Final Environmental Assessment Errata Sheet

West Kingman Traffic Interchange

Mohave County, Arizona

July 2020

Figure 10 Traffic Volumes

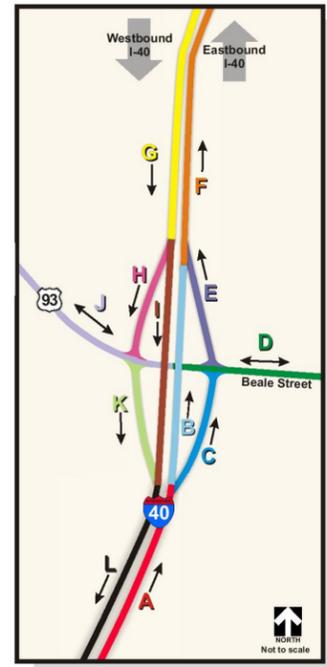
2006 data is inaccurate:
 Data for B = A-C-F-E; however A-C=6,166 & F-E =4,146.
 Therefore, 2,020 vehicles drove off I40 or were sucked off
 the road before "E" traffic merged.

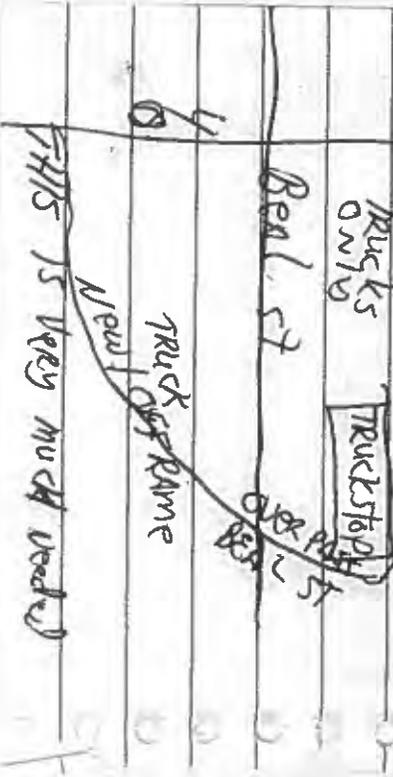
You dont need #93 Int'l
you need to Reroute
Beale st / 40 west
off Ramp to Around
+ over Beal to truck stop
+ truck stop to 40 w
on Ramp thru Empty field

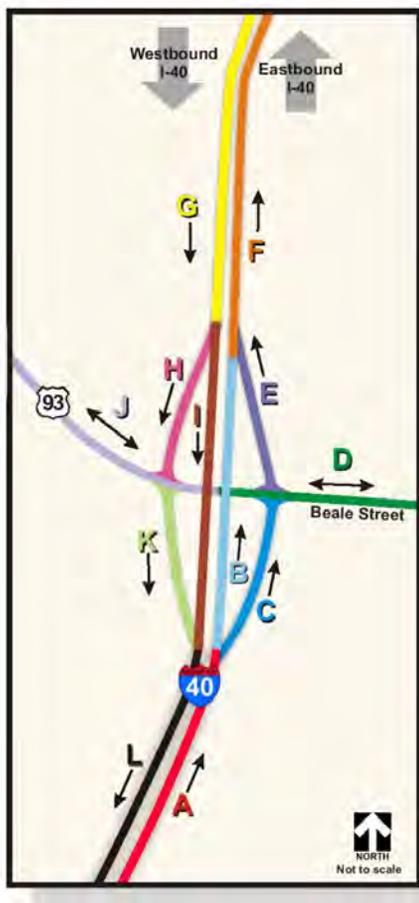
- Additionally, it was not noted whether the current “Phoenix” ramps would be eliminated. These ramps need to be barricaded and no turn lanes provided for their access/departure. This would also allow for the EN Beale Street lane under the I40 overpass to be reopened.

- Phase 1 would need to ensure that US 93 SW traffic could proceed onto Beale Street from the right-hand lane(s). And Beale Street EN traffic could narrow to 1 lane to merge onto US93 from the **left-hand** lane. These modifications would present minor modifications to the existing roadways.

- Phase 2 could be modified as follows:
 - Add turn lane for SW US93/Beale St traffic to merge onto I40 on ramp & perhaps soften the curve at the intersection.
 - Add right-hand lane for I40 eastbound exit to Beale Street east & soften curve.
 - Traffic signals at I40/Beale St intersection would only need to be triggered to change for left-hand turning traffic.
